WATER QUALITY MEMORANDUM

Utah Coal Regulatory Program

RE: 2010 First Quarter Water Monitoring, Genwal Resources, Inc., Crandall Canyon Mine, Permit & Tracking #3473

Total Iron (T-Fe): Outfall 002

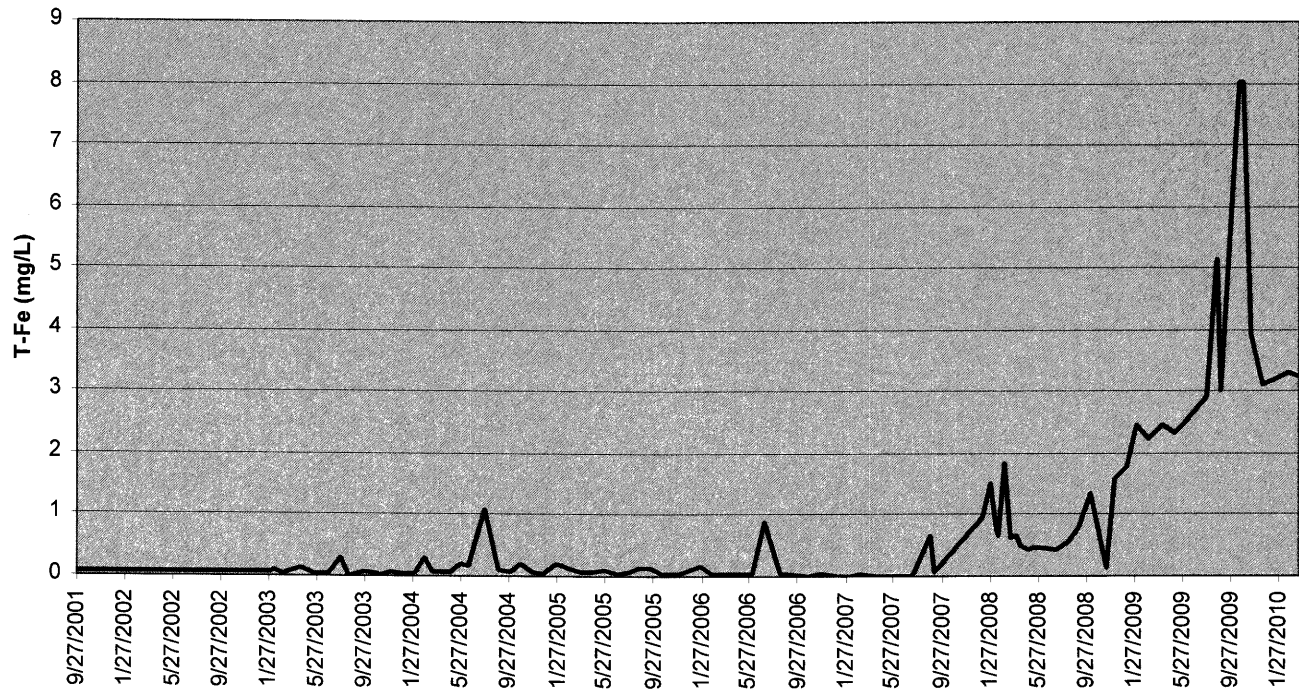
Outfall 002 reported an average flow of 428.3 gpm for the quarter. T-Fe concentrations continue to remain elevated. All three sampling events conducted this quarter produced T-Fe levels above the UPDES limit of 1.0 ppm (3.2 ppm, 3.3 ppm and 3.23 ppm respectively for January, February and March).

Crandall Creek Lower Flume (LOF-1): Total Iron Levels

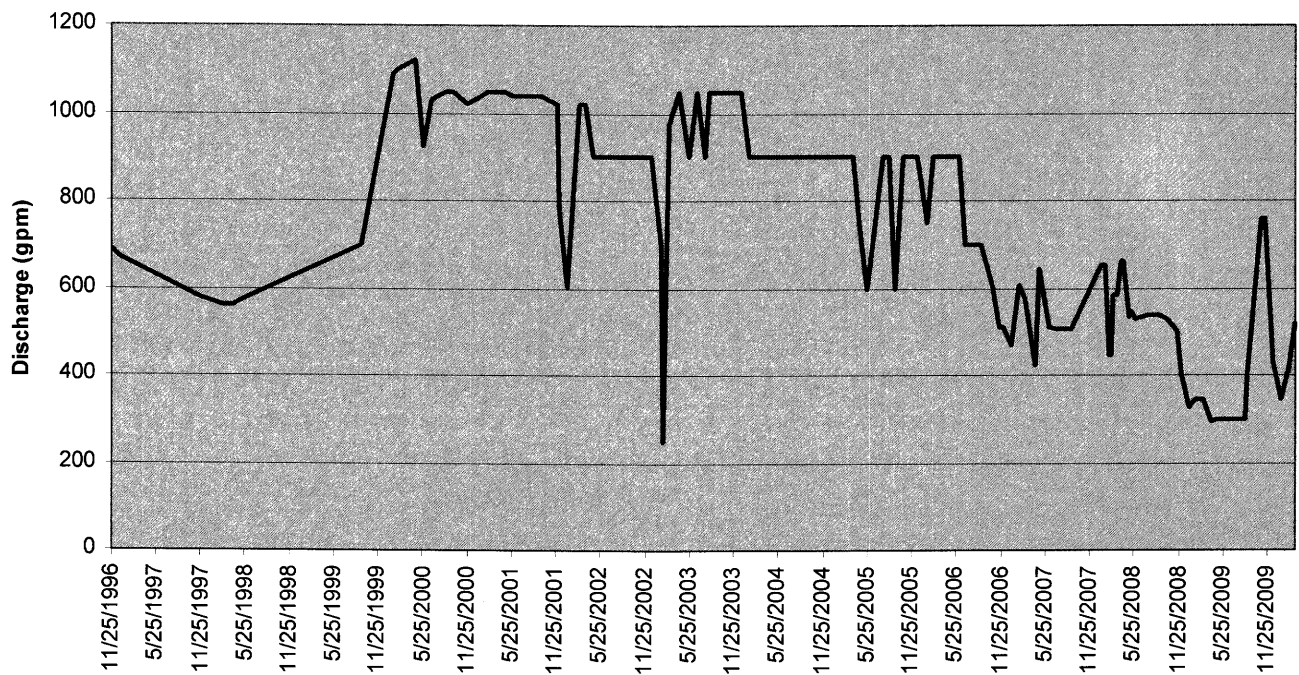
As the total iron (T-Fe) concentrations in the mine-water discharge have increased, a similar rise has been observed in stream monitoring site LOF-1 (lower Crandall Canyon flume). An upward trend of T-Fe began to surface the second quarter of 2008. There have been fluctuations, but the overall trend has been upward. Last quarter's reported T-Fe value at LOF-1 was 1.479 mg/L. However, this quarter's reported value was 0.503 mg/L. Continued monitoring will be conducted in order to ascertain a relationship between the T-Fe concentrations in the mine-water discharge and the receiving stream.
